SUBJECT: ARKANSAS NUCLEAR ONE, UNITS 1 AND 2 – FLOOD HAZARD MITIGATION STRATEGIES ASSESSMENT (CAC NOS. MF7894 AND MF7895: EPID L-2016-JLD-0007)

STAFF ASSESSMENT RELATED TO THE
MITIGATION STRATEGIES FOR
ARKANSAS NUCLEAR ONE, UNITS 1 AND 2
AS A RESULT OF THE REEVALUATED FLOODING HAZARDS REPORT
NEAR-TERM TASK FORCE RECOMMENDATION 2.1- FLOODING
CAC NOS. MF7894 AND MF7895

Figure 3.2-1 FLEX Equipment Deployment Routes and Staging Location (adapted from Figure A-1 of Entergy's May 31, 2017, submittal (ADAMS Accession No. ML17153A295))

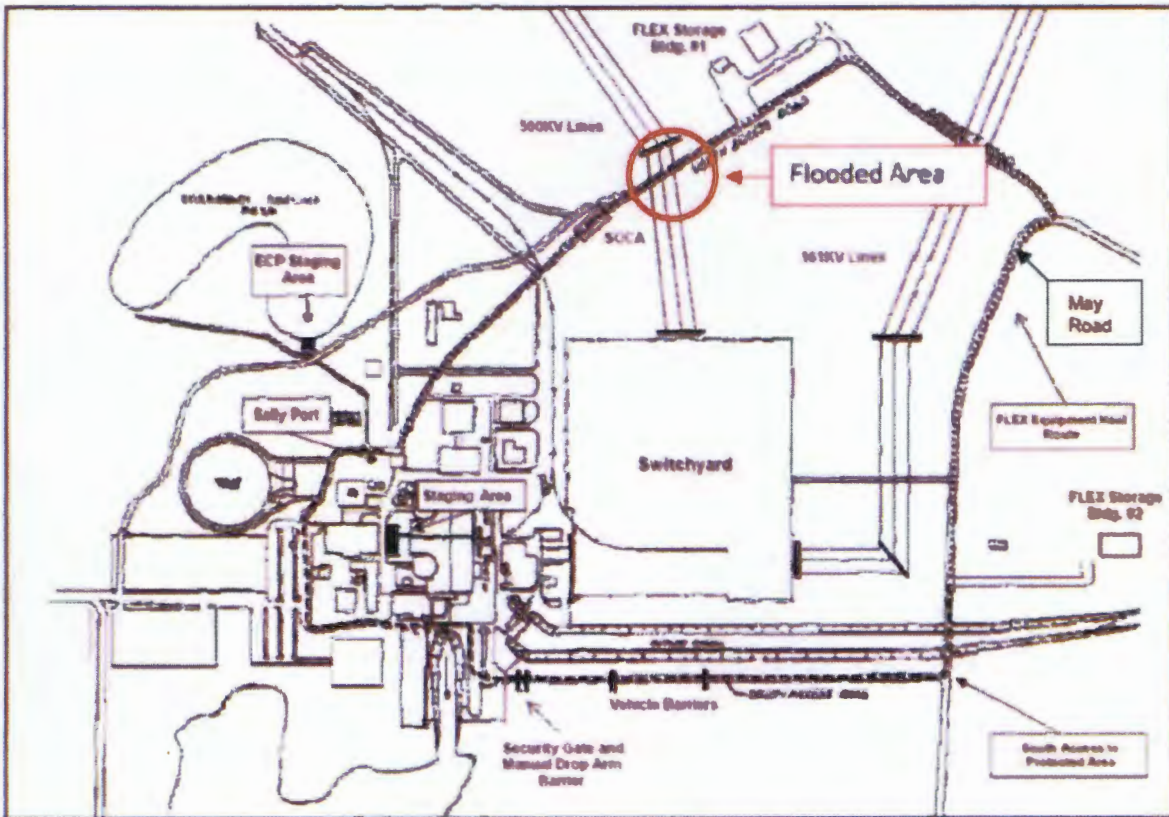
The staff notes that based on the FHRR, the flooding around the staging area (see Figure 3.2-1) is minimal and below the ground clearance of the FLEX equipment. The licensee also included a commitment in its MSA to either establish trigger-point entry conditions and appropriate procedural changes to prestage the FLEX equipment or to modify the road such that the deployment path is not affected by the LIP. Since warning time is available prior to the onset of the LIP, the NRC staff finds it reasonable that the modified FLEX strategy (i.e., prestaging of FLEX equipment) can be implemented as intended. Alternatively, the staff notes that modifications to the FLEX strategy would not be needed if the licensee changes the North Access Road elevation such that deployment of the FLEX equipment is not impacted by the LIP event.
